Product Change Notification / NTDO-28PSRS829

CCB 4681 Initial Notice: Qualification of STAR as an additional assembly site for selected Micrel products available in 6L VDFN (7x5x0.9 mm) package.

CCB 4681
Pre and Post Change Summary
PCN #: NTDO-28PSRS829

LEAD FRAME COMPARISON

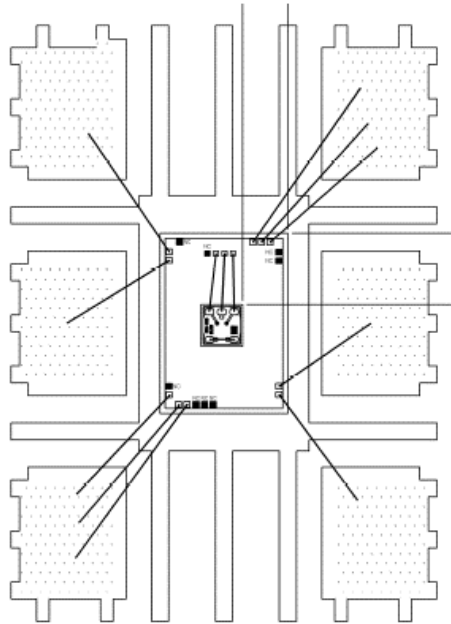
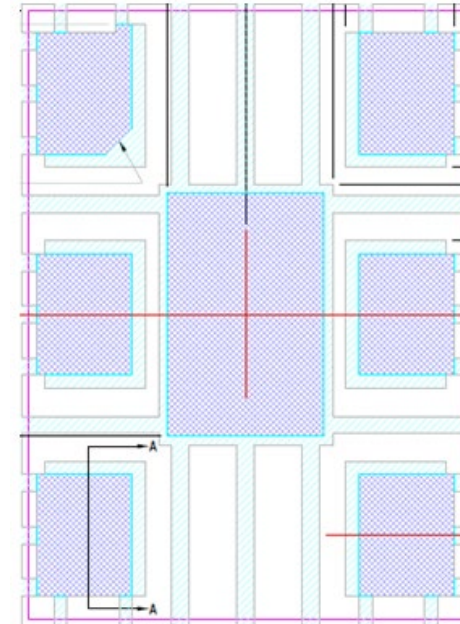
Leadframe Material	A194
Lead Lock (Locking Hole)	Yes
Lead Plating	NiPdAu

Leadframe Material	C194
Lead Lock (Locking Hole)	Yes
Lead Plating	NiPdAu

Note: The lead lock hole fills with mold compound during the assembly process and provides improved protection against moisture penetration around the interface edges between pins and mold compound.

LEAD FRAME COMPARISON

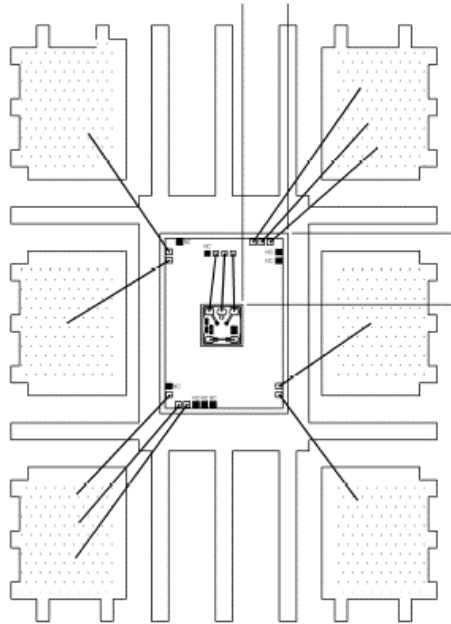
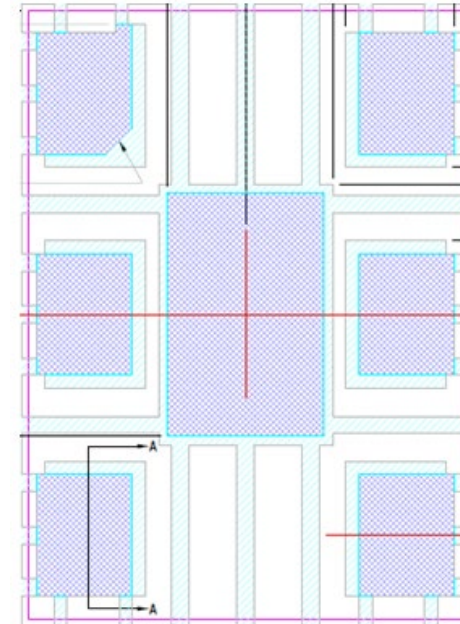
Leadframe Material	C194
Lead Lock (Locking Hole)	Yes
Lead Plating	NiPdAu

Leadframe Material	C194
Lead Lock (Locking Hole)	Yes
Lead Plating	NiPdAu

Note: The lead lock hole fills with mold compound during the assembly process and provides improved protection against moisture penetration around the interface edges between pins and mold compound.
